CHANGE ORDER NUMBER: 1

Project: 1812-282

Roadway: Seward Junction

1A: Design Error or Omission. Incorrect PS&E. This change order revises items and quantities that were entered incorrectly or omitted in the bid tab for Seward Junction SW, Seward Junction SE and PEC Pond.

TYPICAL SECTIONS

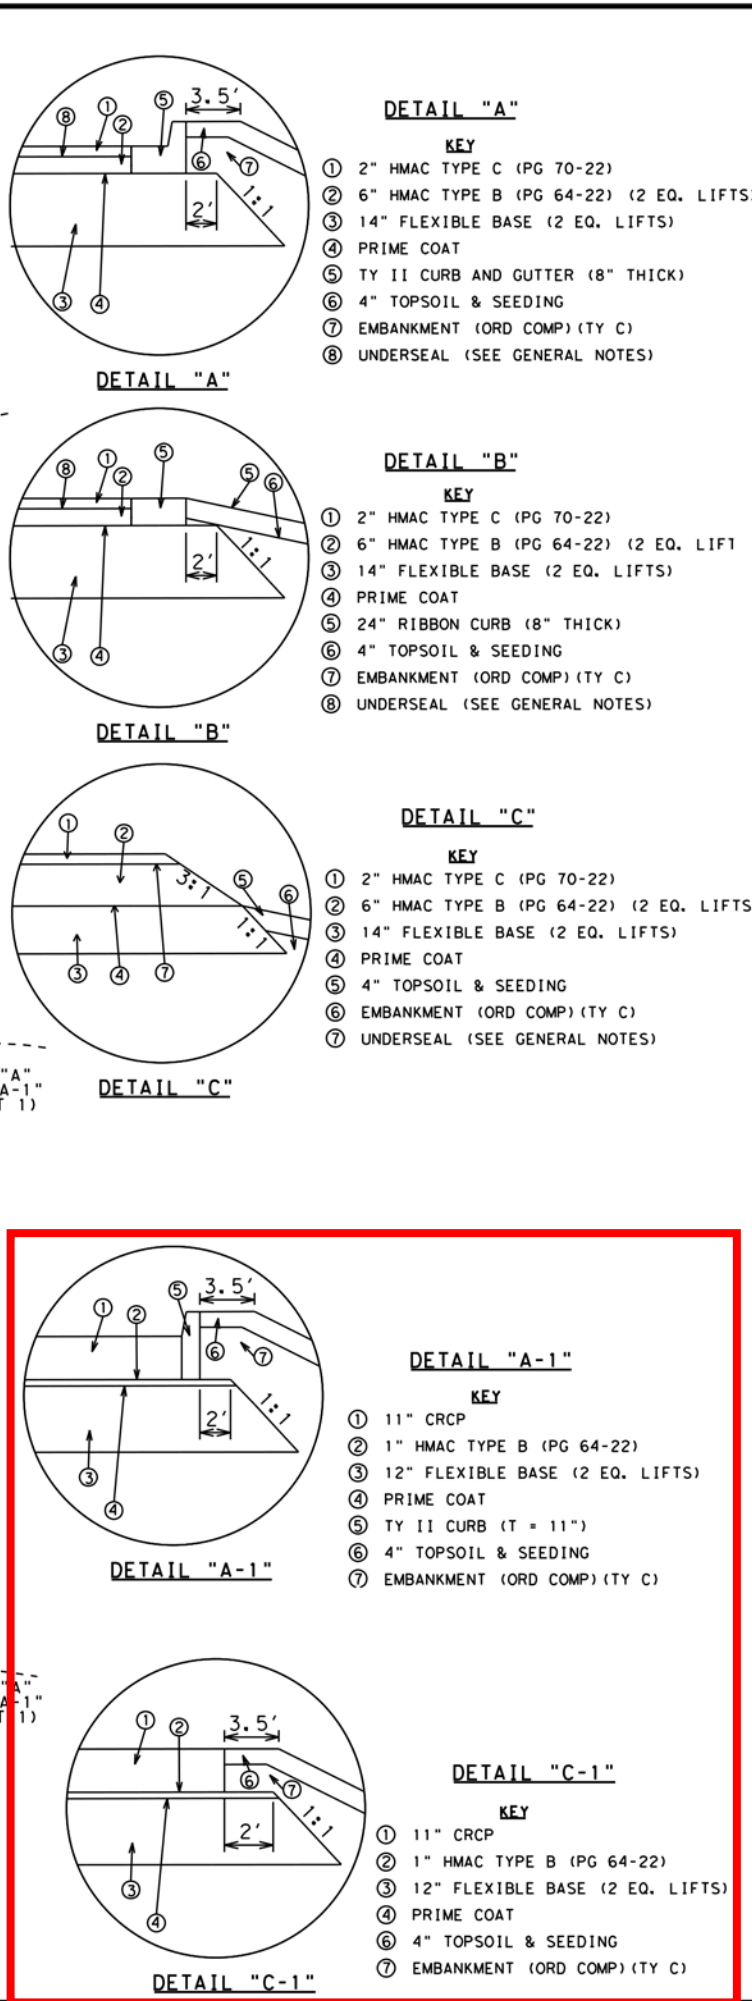
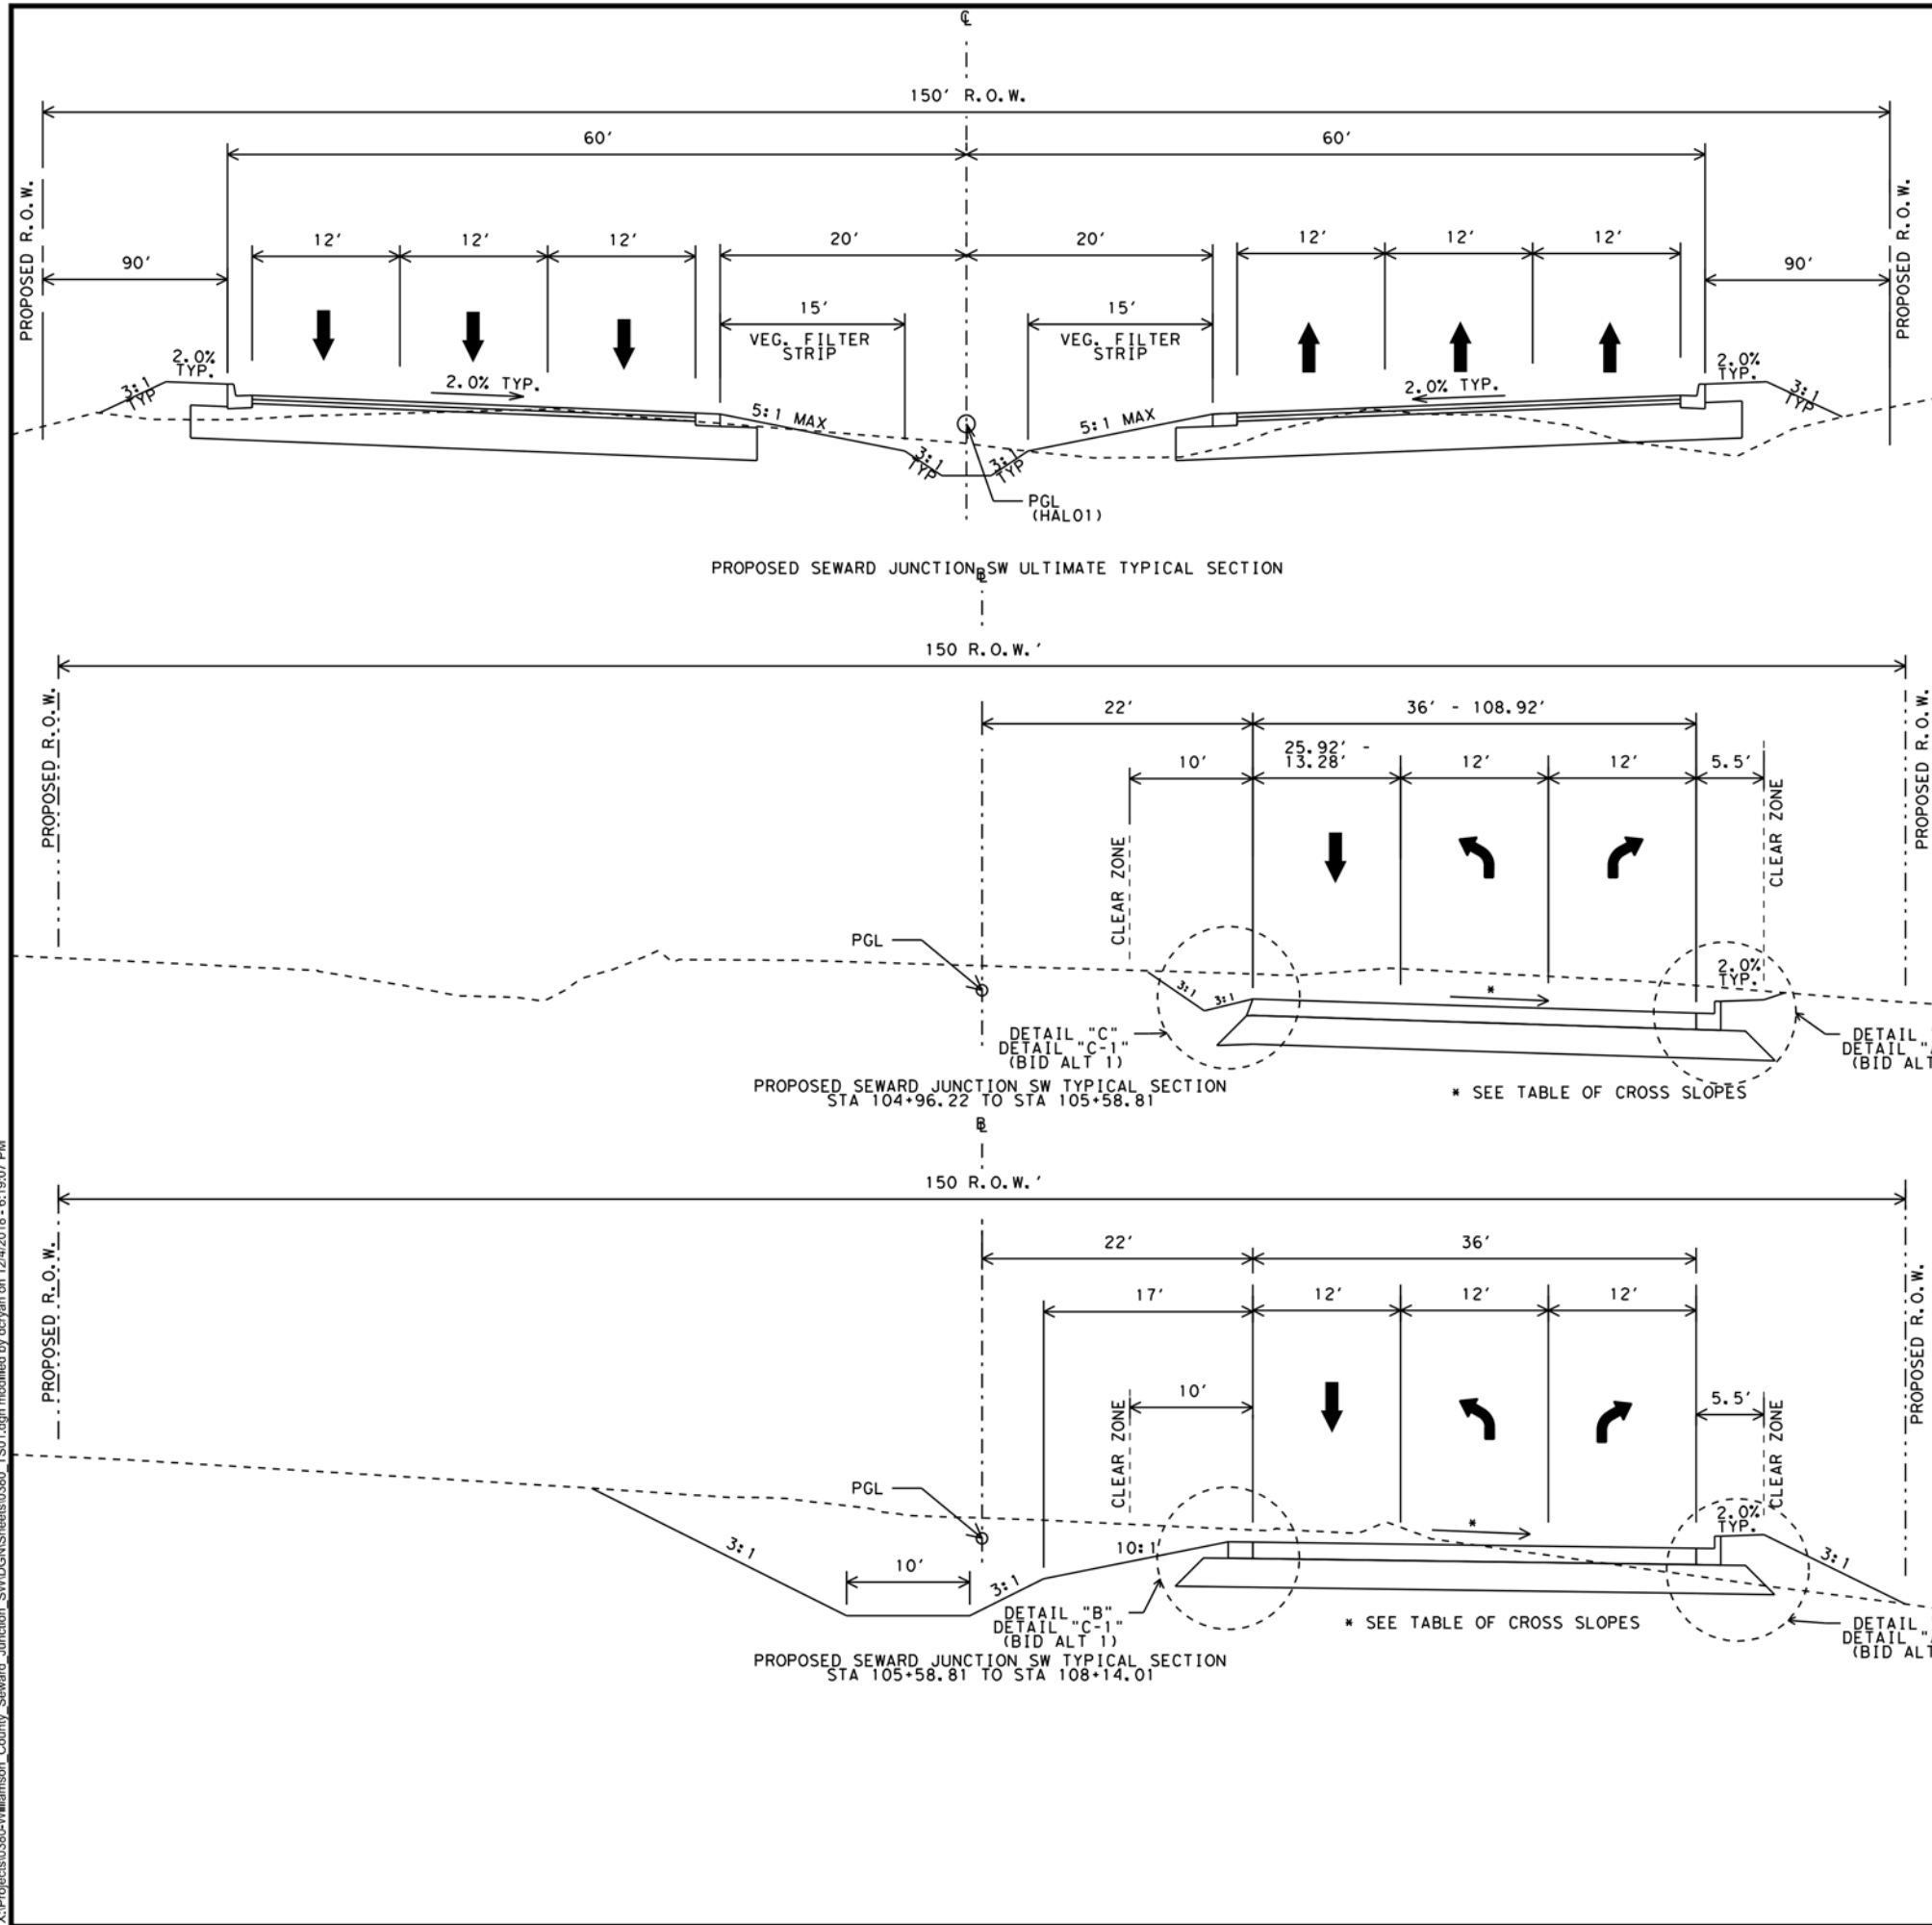
As the quantity matches the sections, JFC is currently under the assumption that the typical representing CRCP indicated as Detail "A-1" and "C-1" on the enclosed plan sheet will be the proposed typical for the Southwest including CR 263 and Falcon Ln and the Southeast including CR 266. Also, CR 213 including SH 29 will be the typical representing HMA indicated as Detail "D" on the enclosed plan sheet, and the South including the US 183 crossover will be the typical representing HMA indicated as Detail "A" on the enclosed plan sheet.. JFC requests clarification regarding the proposed typical sections to be constructed throughout the project.

The typical concrete section for Seward Junction Southeast will be the same as Seward Junction Southwest : 11" CRCP, 1" HMA Type B (PG 64-22), Prime Coat & 12" Flexbase per Detail A-1 and D-1 in the Southwest plans and part of this document.
